RE: Application SE 1-20-10: 142 East Haddam Road – Response to Comments

Comments from the Salem Planning and Zoning Commission at its Meeting on August 25, 2020

Proposed 925-gallon Fuel Tank with Secondary Containment

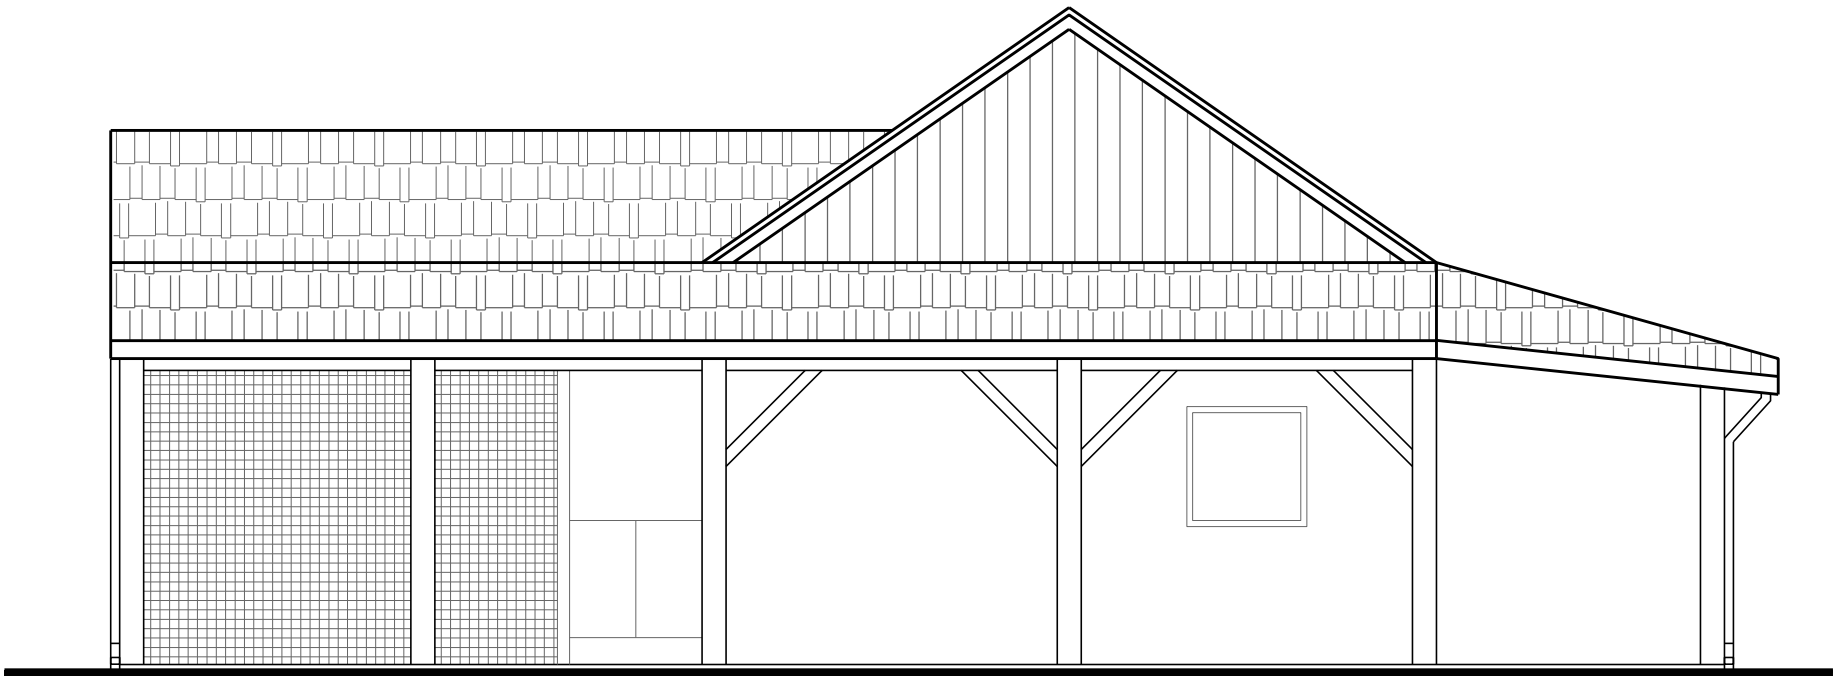
6. The applicant should comment on the storage capacity of the fuel tank containment pad proposed. *The fuel tank and secondary containment system have been revised. The Applicant is proposing to install a 925-gallon, single wall steel tank with a secondary steel containment system that can hold 1137 gallons (which is a volume 23% greater than the fuel tank). The secondary containment system has sides to prevent rain or snow from entering the system. See attached photo of fuel tank with secondary containment*

2. 1,000-gallon diesel fuel tank must be protected from the elements. *The fuel tank and secondary containment system have been revised. The Applicant is proposing to install a 925-gallon, single wall steel tank with a secondary steel containment system that can hold 1137 gallons (which is a volume 23% greater than the fuel tank). The secondary containment system has sides to prevent rain or snow from entering the system. See attached photo of fuel tank with secondary containment system.*

1. Please provide the plan for fuel and oil leaks that may occur with the equipment planned to be parked at the Site. *The Applicant will have multiple spill kits on-site and employees are trained to look for spills and clean as necessary. The fuel tank and secondary containment system have been revised. The Applicant is proposing to install a 925-gallon, single wall steel tank with a secondary steel containment system that can hold 1137 gallons (which is a volume 23% greater than the fuel tank). The secondary containment system has sides to prevent rain or snow from entering the system. See attached photo of fuel tank with secondary containment system.*

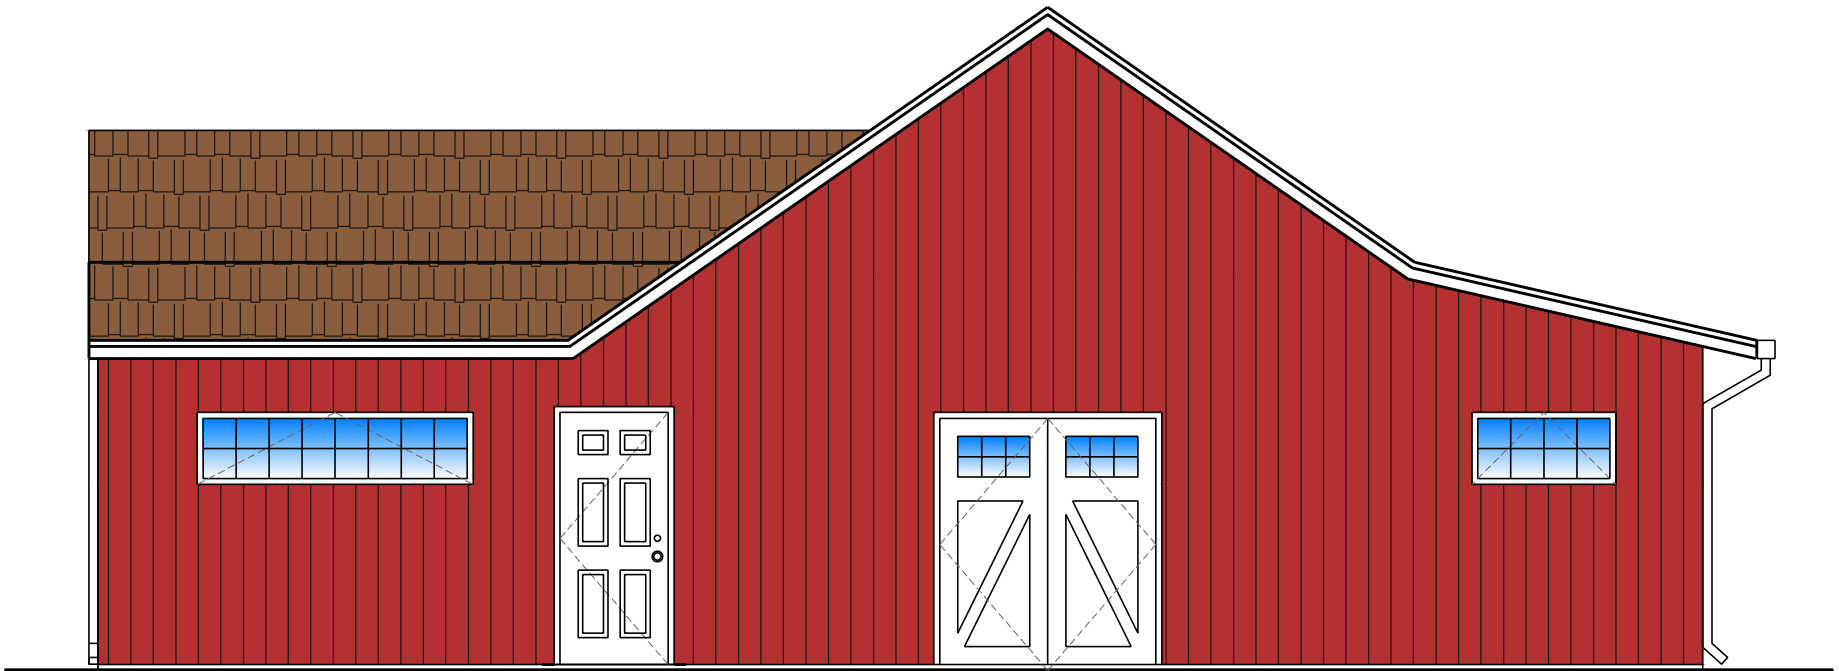
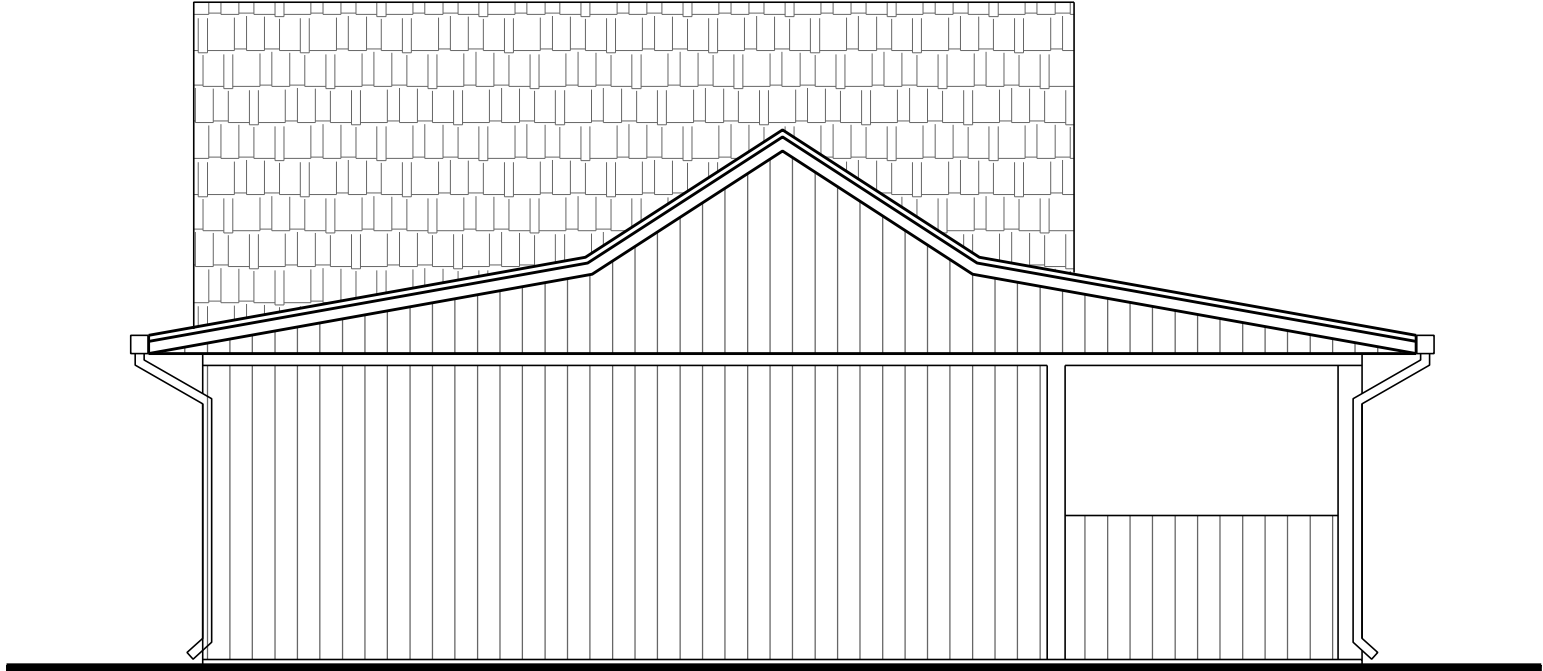
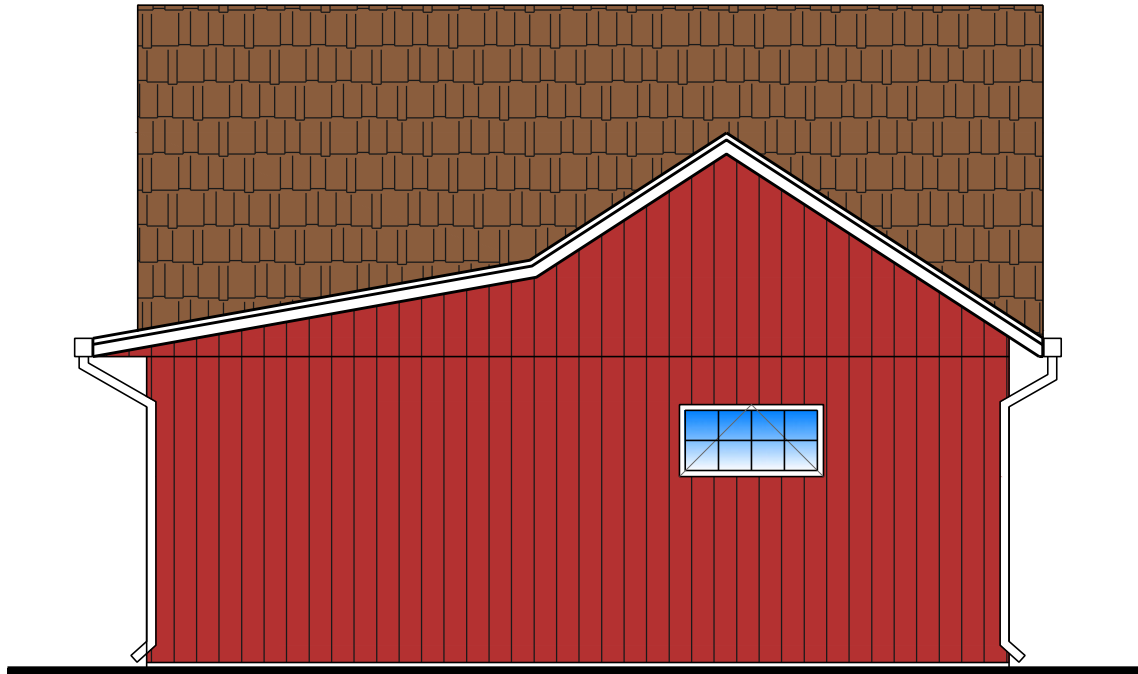
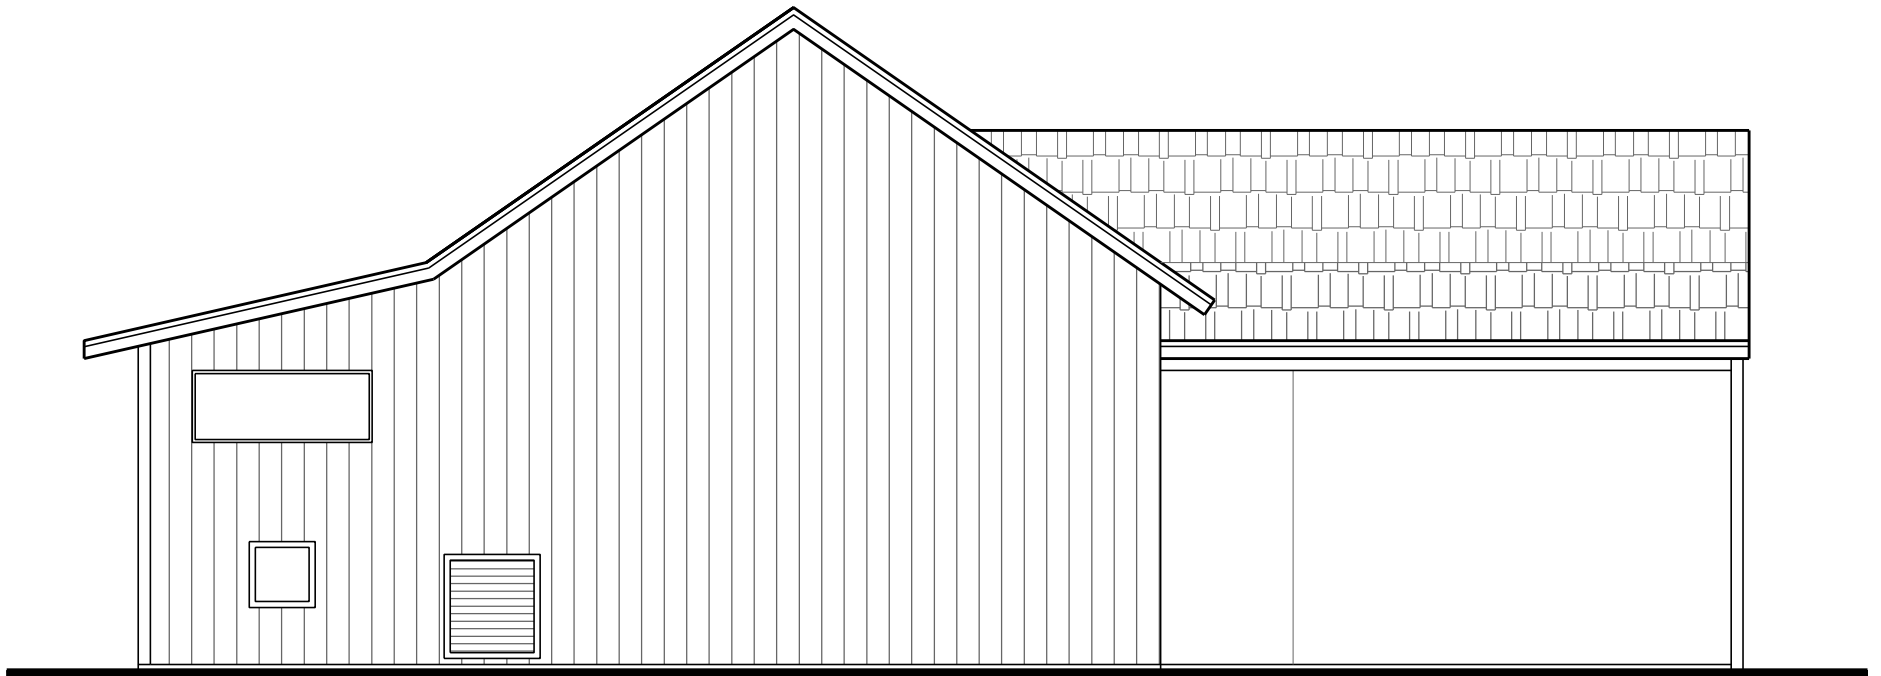
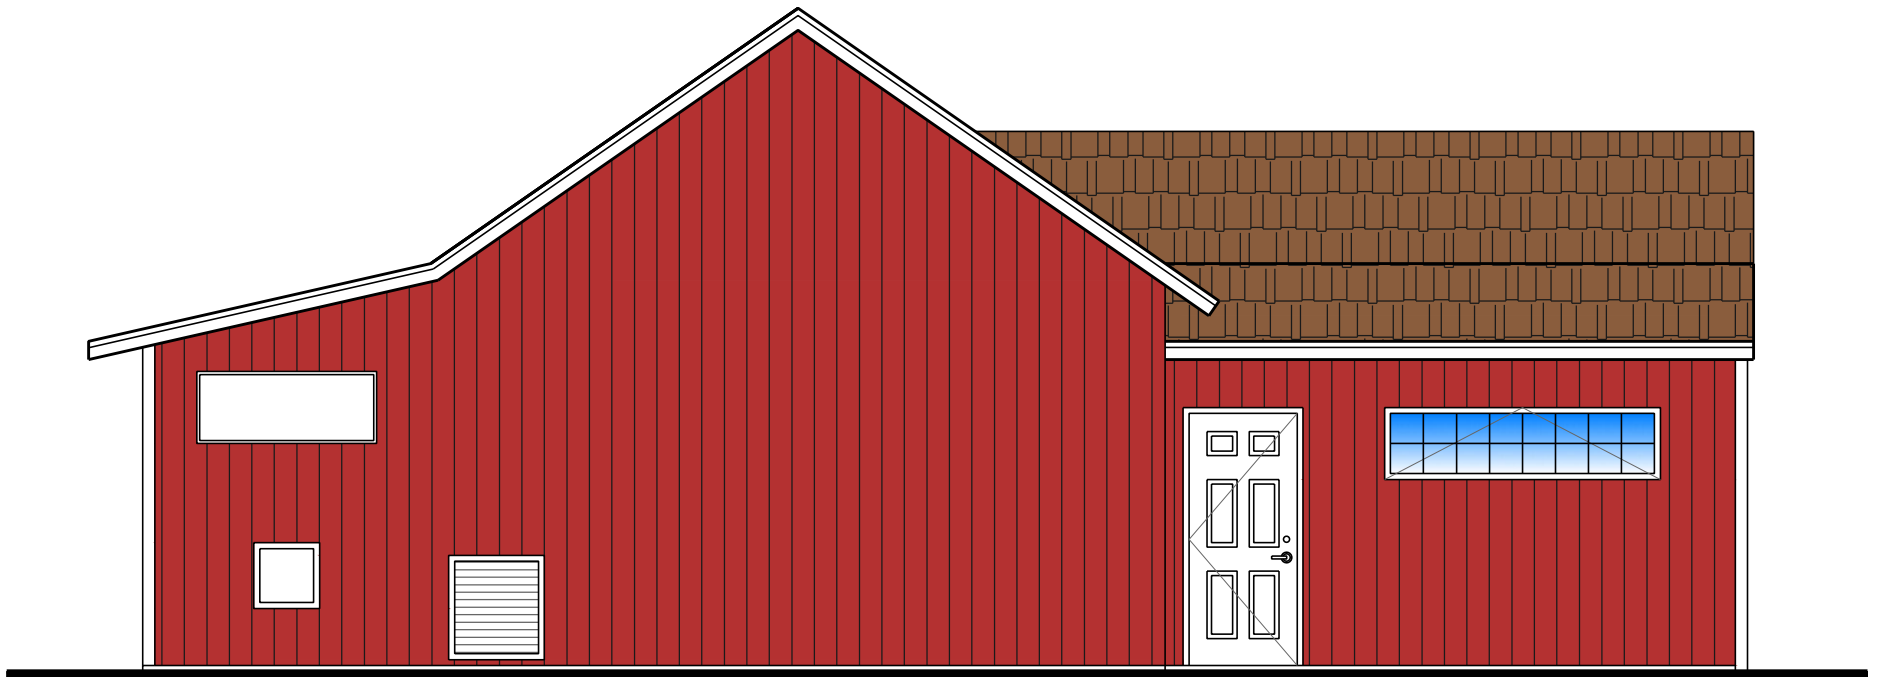
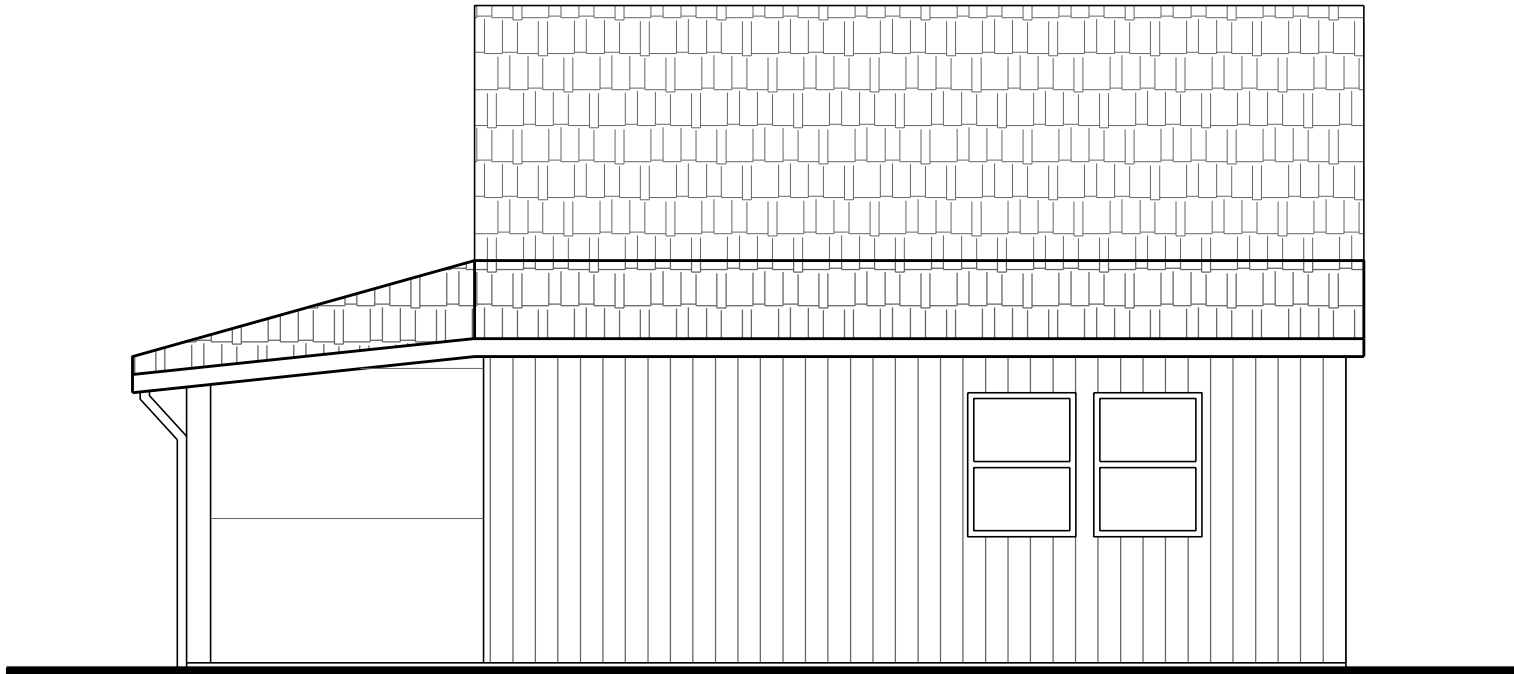
12. Can we provide some perspective on what the building will look like such as an elevation drawing. *Attached please find existing building elevations and proposed building elevations. The Applicant is proposing to remove the front overhang of the building, enclose the breezeway with front and rear doors, add double swinging barn doors to the front of the building, add windows and paint the building a barn red color. The Applicant is no longer proposing to raise the roof; therefore, the existing roof will remain.*
